Access Compliance Report

Public Rights-of-Way

(Curb Ramps)

Intersection ID: 10023378	Main Street: CHINA GROVE CHURCH RD	Cross Street: N/A	Location: SE
ADA ID: CEE081E4470F	Ramp Type: PerpDiag	Initial Pass/Fail: Fail	Overall Compliance: No
Codes/Mitigation Info/Possible Solution		Field Measurements/Component Compliance	
Severity Score: 21.25

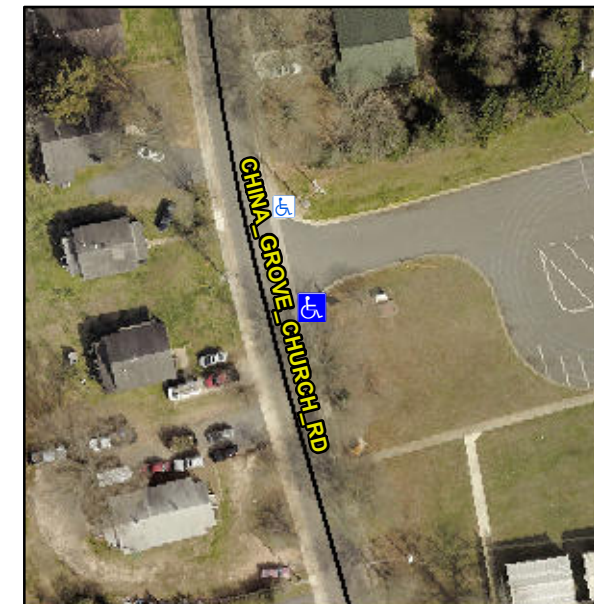
Not Found, R304.5.1, R304.2.2

Compliance	Description	Data	Compliance	Description	Data
N/A	Ramp Length (in)	63.0	No	Ramp Slope (%)	8.7
No	Ramp Width (in)	44.0	Yes	Ramp XSlope (%)	1.2
N/A	Flare Type LT	N/A	N/A	Flare Type RT	N/A
N/A	Flare Slope LT (%)	N/A	N/A	Flare Slope RT (%)	N/A
N/A	Flare Traversable LT?	N/A	N/A	Flare Traversable RT?	N/A
N/A	Landing Length (in)	N/A	N/A	DWS Provided?	N/A
N/A	Landing Width (in)	N/A	N/A	DWS Contrast?	N/A
N/A	Landing Slope (%)	N/A	N/A	DWS Length (in)	N/A
N/A	Landing X Slope (%)	N/A	N/A	DWS Full Width?	N/A
N/A	Landing Curb? (Y/N)	N/A	N/A	DWS Offset (in)	N/A
N/A	Shared Landing?	N/A			
N/A	Gutter Ponding?	N/A	N/A	Gutter Slope (%)	N/A
N/A	Gutter Lip Ht (in)	N/A	N/A	Gutter X Slope (%)	N/A
N/A	Painted X Walk1?	No	N/A	Painted X Walk2?	No
	X Walk 1 Direction	To N		X Walk 2 Direction	To W
N/A	X Walk 1 Width (in)	N/A	N/A	X Walk 2 Width (in)	N/A
	X Walk 1 Slope (%)	0.9		X Walk 2 Slope (%)	1.4
	X Walk 1 X Slope (%)	2.5		X Walk 2 X Slope (%)	1.2

Remove & Replace Curb Ramp With Two New Directional Ramps or Equivalent.
